Subject:

1. Inspecting the elevator engaging actuator (on the top of the fin) in accordance with the instructions given in the manuals.
2. Editorial corrections in the Flight and Maintenance Manuals.
3. Exchange of the Engine Manual.
4. Replacement of one hose sleeve in the flexible fuel tank system in the wing.

ASH 25 E
Technical Note
No. 4

Alexander Schleicher
GmbH & Co.
Segelflugzeugbau
D-6416 Poppenhausen

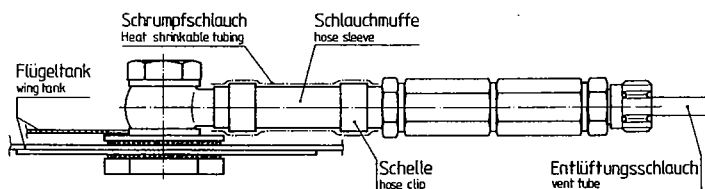
- Ad 3.: The manual for the engine Rotax 275 has had a revision. Valid is now the engine manual with the entry "Revision no.1 dated 22.Jan.91".
- Ad 4.: Some of the flexible wing fuel tank systems use a short hose sleeve made from plastic tube in the vent tube. In course of time this plastic hose sleeve may become leaking and so this item must be replaced by a hose sleeve made from fuel tube (fabric-covered rubber).

Ad 4.: On those gliders affected by this Point 4 the flexible wing fuel tanks must be removed from the inner wings following the instructions in Section 2 of the Maintenance Manual and the hose sleeve in the vent tube must be inspected according to the sketch on page 1 of this TN. If the hose sleeve is made from plastic tube, it must be replaced by a sleeve made from fuel tube (fabric-covered rubber). The hose clips must again be coated by heat shrinkable tubing.

Ad 4.: The new hose sleeve made from fuel tube (fabric-covered rubber), the two hose clips and the heat shrinkable tubing can be obtained from Messrs. Schleicher.
